PARKSIDE MONTESSORI MPR AND SITE PROJECT

ADDENDUM NO. 4

Date: November 21, 2023

Project: Parkside Montessori MPR & Site Project
DSA #: 01-120306 41-26

C1.1

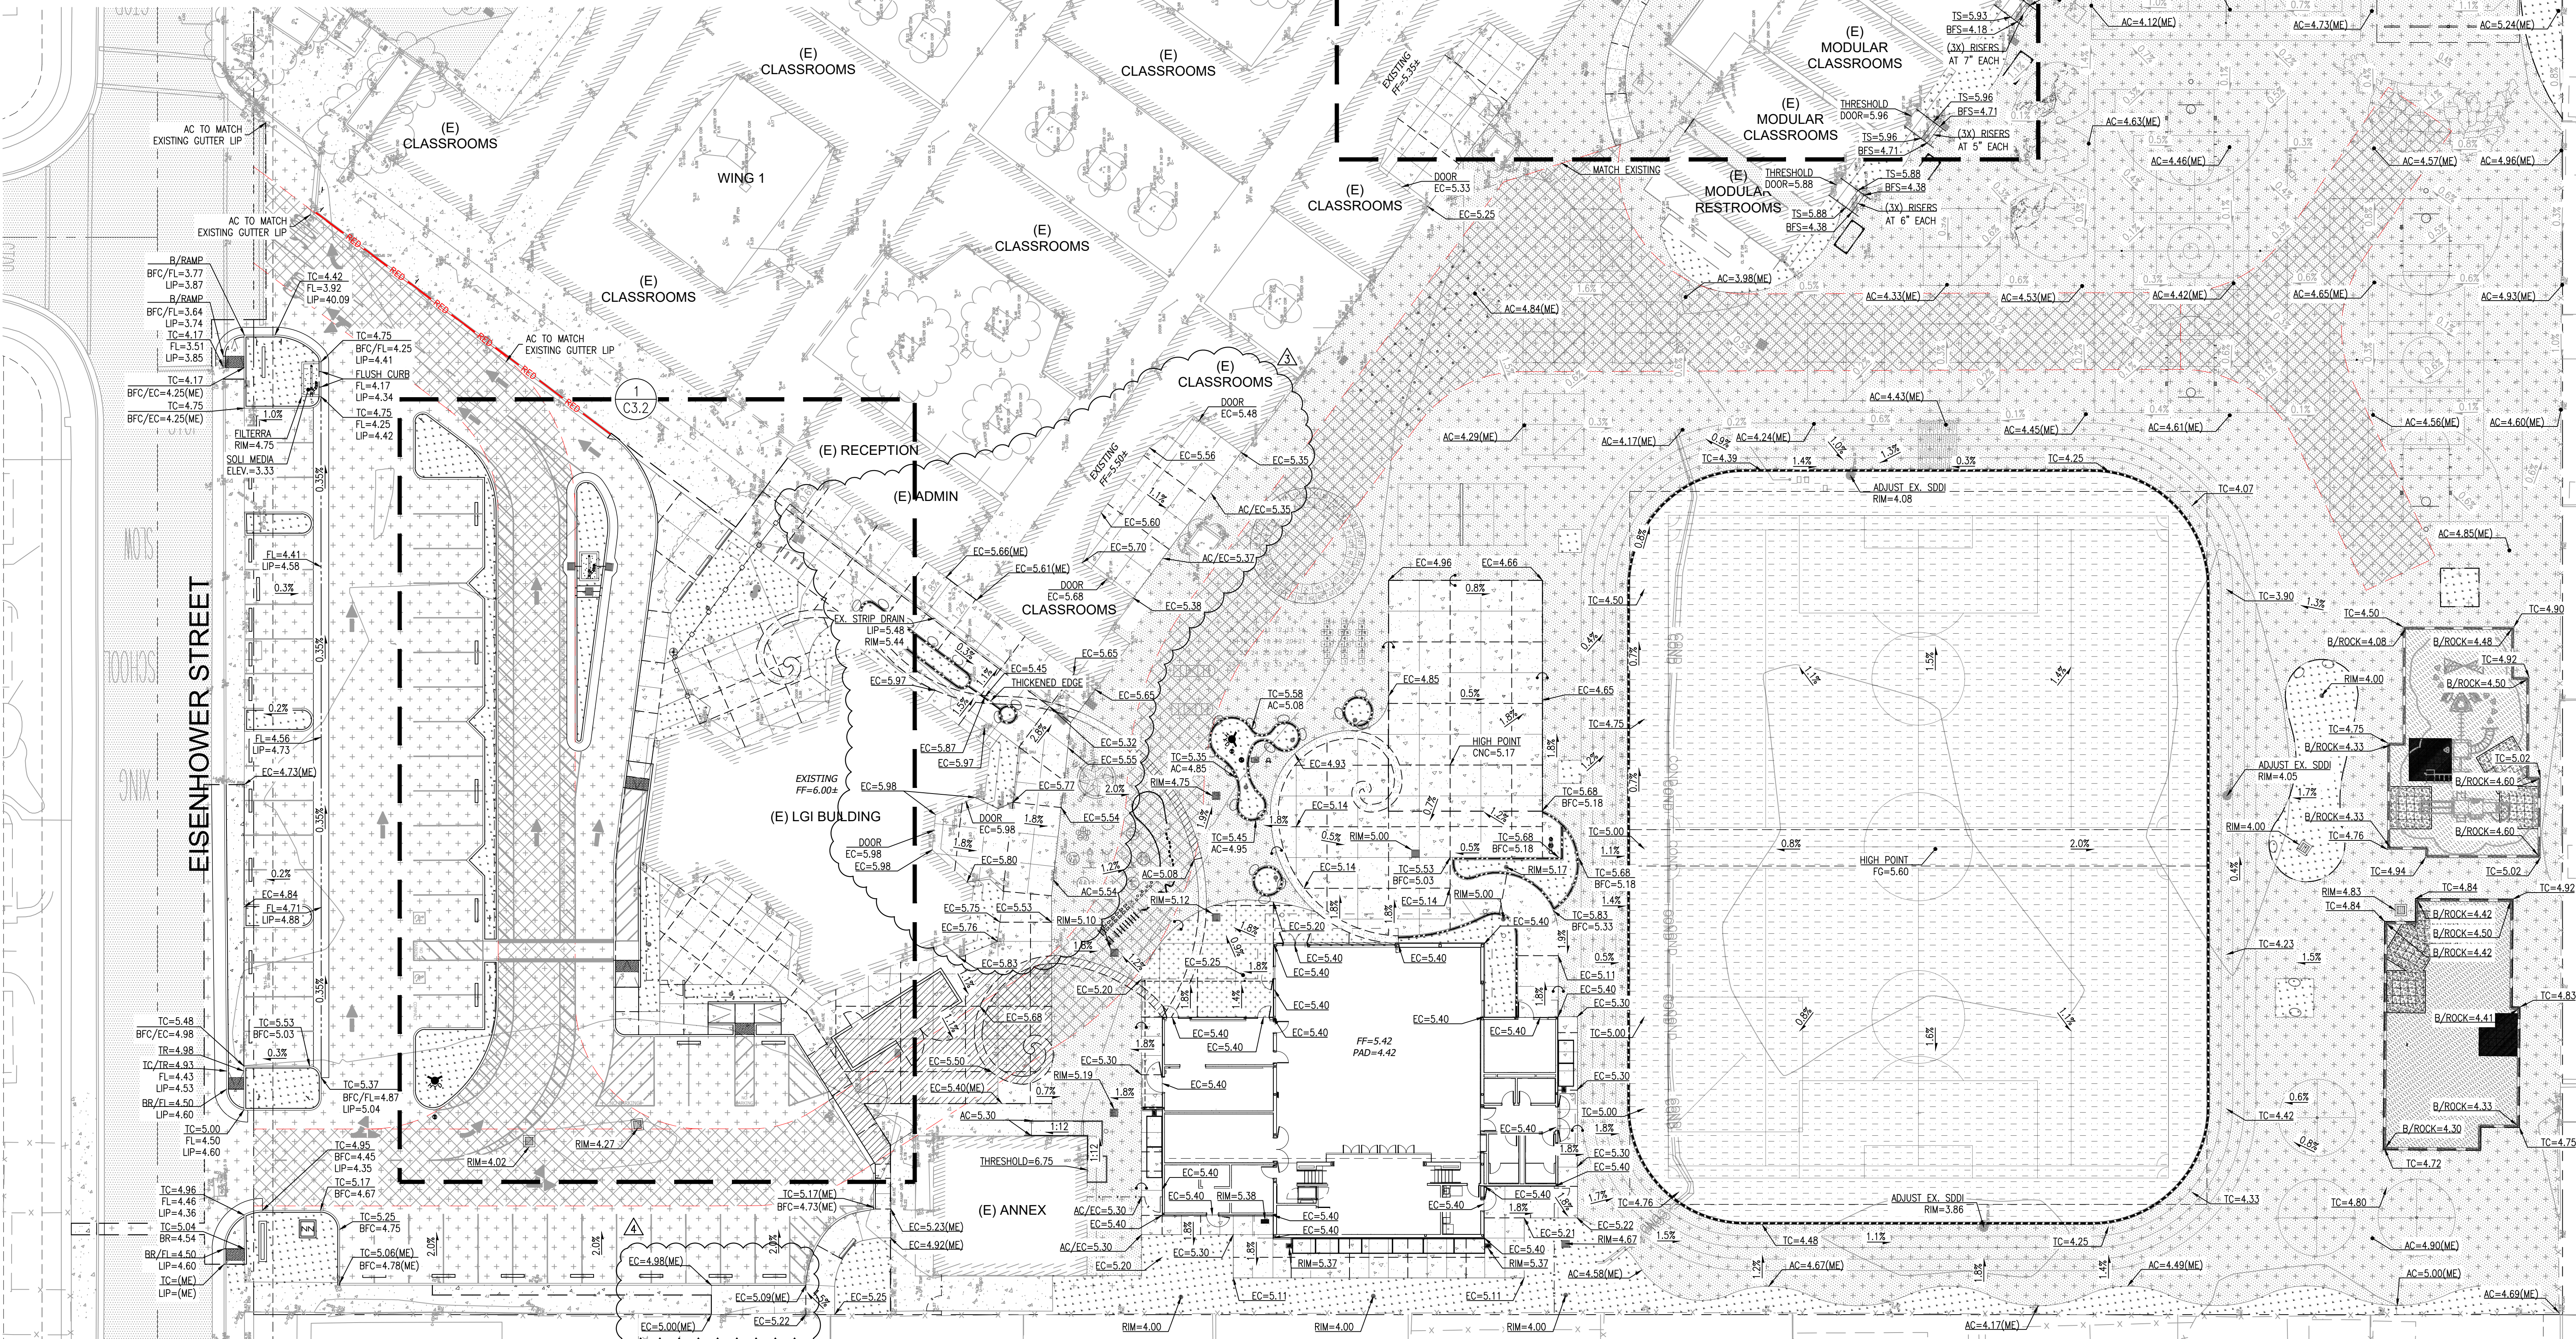
2. **SHEET ‘C1.1 EXISTING SITE & DEMOLITION PLAN’**

- A. Added existing concrete to be remove in front of existing classrooms and LGI building
- B. Added existing gate in front of administration office to be removed
- C. Added Demolition Note #51
- D. Revised Over-Excavation & Recompaction Notes #2 and #4
- E. Added note #8 to Project Description.

Q: Plan sheet C1.1 Site Demolition, states "OVER-EXCAVATION & RECOMPACTION NOTES - #2. THE BUILDING PAD SHALL BE EXCAVATED TO A MINIMUM DEPTH OF 12-INCHES BELOW FINISH FLOOR AND THE UPPER 12-INCHES OF SUBGRADE SHALL BE COMPACTED PER GEOTECHNICAL REPORT RECOMMENDATIONS." Since the building foundation is a 12" PCC Mat slab, and the finished floor is 12" above the pad, there would be nothing to over-excavate. Shall we bid to over-excavate the pad grade by 12", compact that over-ex sub grade, and backfill the 12" up to pad grade, while compacting?

Q: Plan sheet C1.1 Site Demolition, states "OVER-EXCAVATION & RECOMPACTION NOTES - #4. AREAS TO RECEIVE FLATWORK SHALL BE OVER-EXCAVATED TO A MINIMUM DEPTH OF 12-INCHES BELOW FINISH GRADE..." Since all concrete flatwork will be either 4" PCC/12" AB (SG is 1.33' below FG), or 6" PCC/12" AB (SG is 1.5' below FG), there is nothing to over-excavate. Shall we bid to over-excavate the concrete flatwork sub-grade areas by 12", compact that over-ex sub-grade, and backfill the 12" up to the concrete flatwork sub-grade, while compacting?

Q: Plan sheet C1.1 Site Demolition, states "DEMOLITION KEY NOTES - #35 REMOVE ONLY THE AC PAVEMENT. EXISTING BASEROCK SHALL REMAIN... PRIOR TO REMOVAL CONTRACTOR SHALL VERIFY EXACT AC DEPTH FOR NEW AC PAVEMENT INSTALLATION" The new asphalt section must be the same as the existing asphalt section, which is not specified. The boring logs in the soils report states 2 areas have 1.5" of AC and one area has 2" of AC. For bidding purposes, to keep all competing bids comparable, may we bid on removing 2" of AC and replacing 2" of AC at area #35?

- A: Response has been included in Addendum 4 Sheet C1.1.

- A: Response has been included in Addendum 4 Sheet C1.1.

A: Existing AC pavement shall be an assumed 2" remove and replace due to the varying AC pavement section across the site.

C3.1

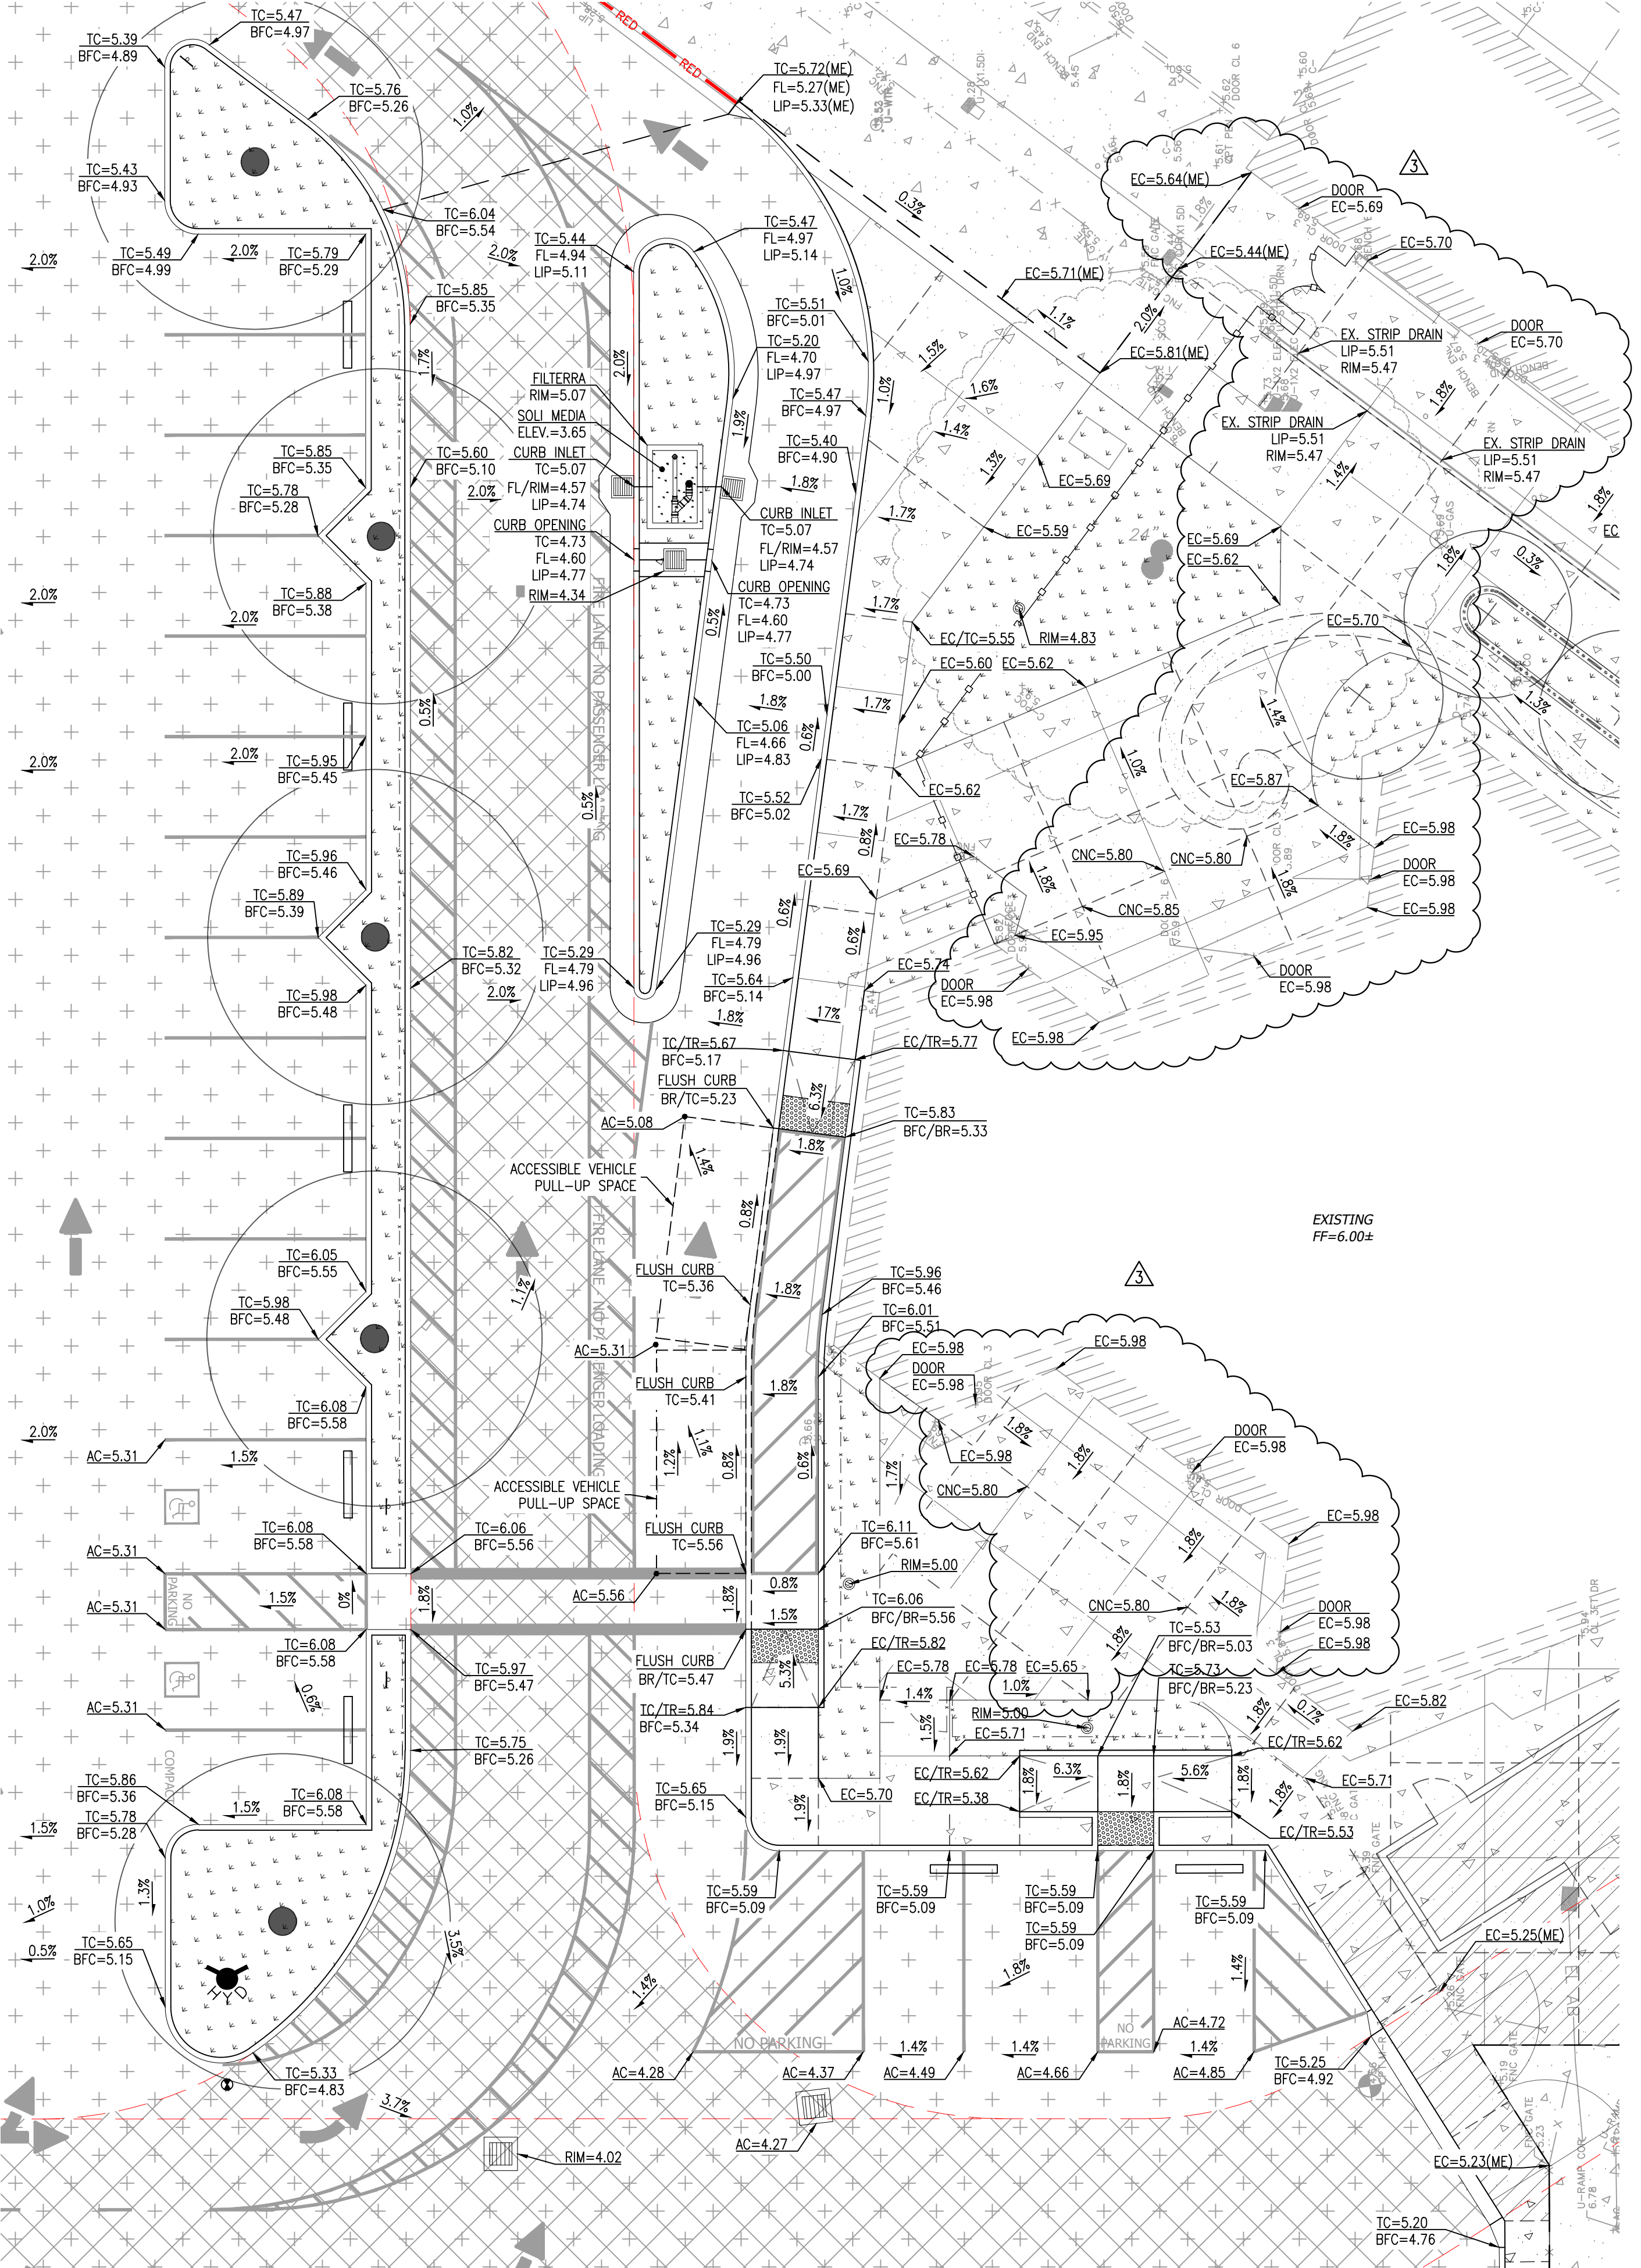
4. **SHEET ‘C3.1 GRADING PLAN’**

- A. Added elevations and slopes to the added concrete outside the existing classrooms and LGI building.

C6.1

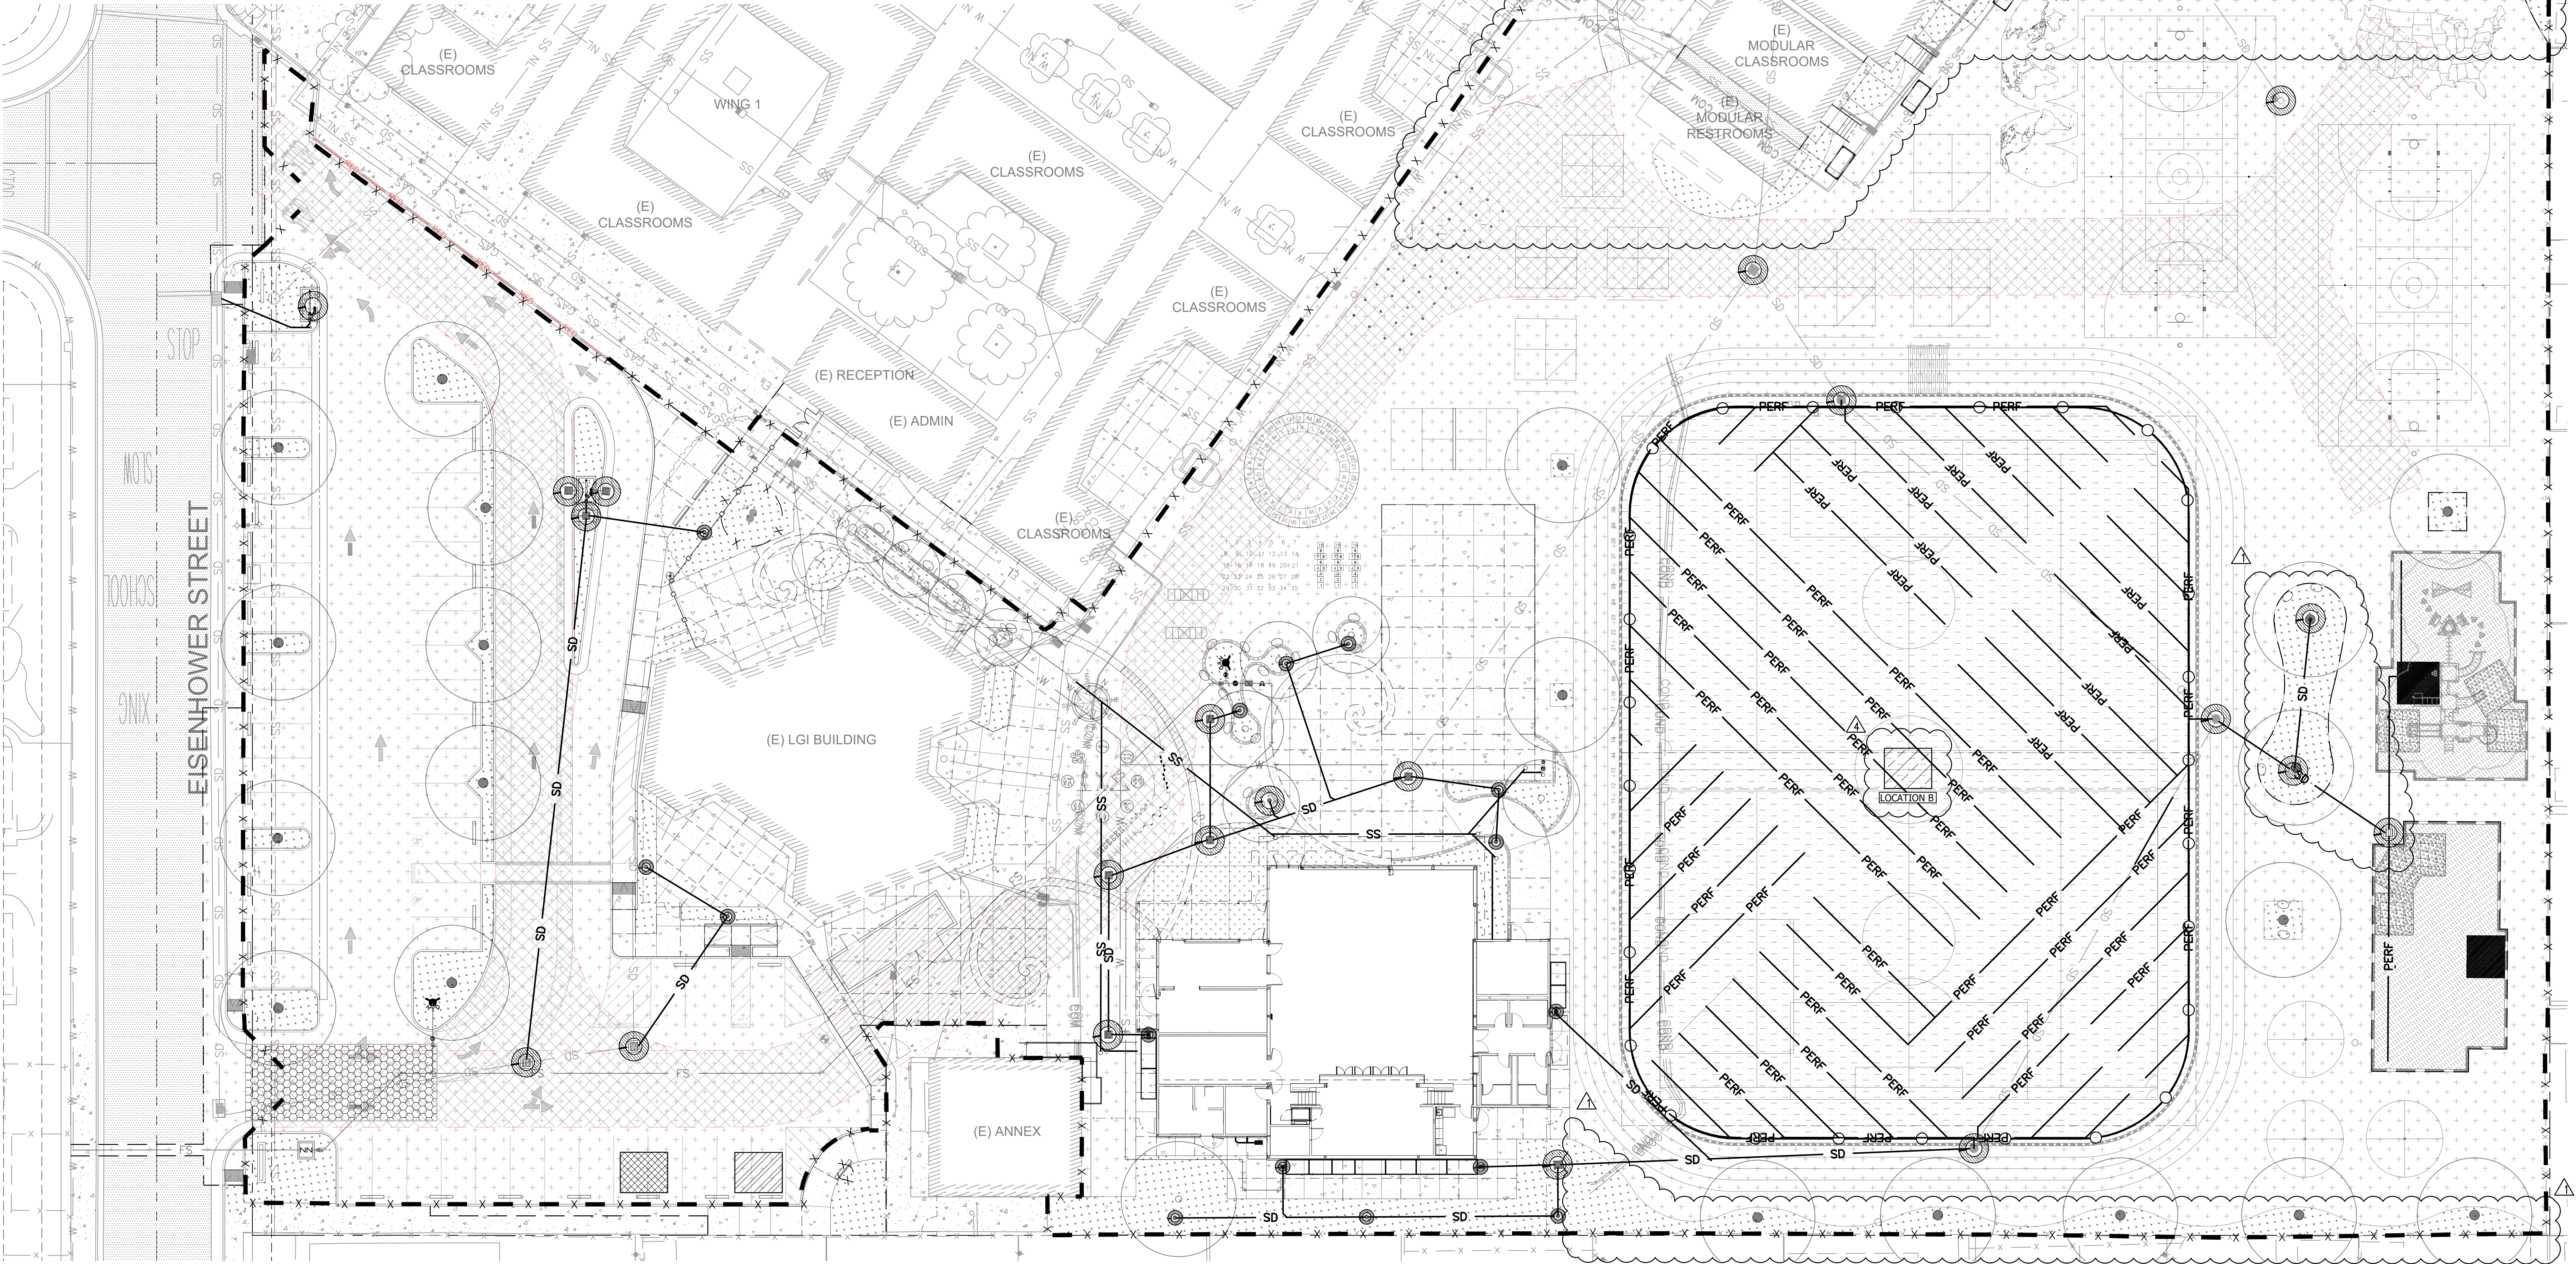
6. **SHEET ‘C6.1 EROSION CONTROL PLAN’**

- A. Added soil and boulder stockpile locations A & B
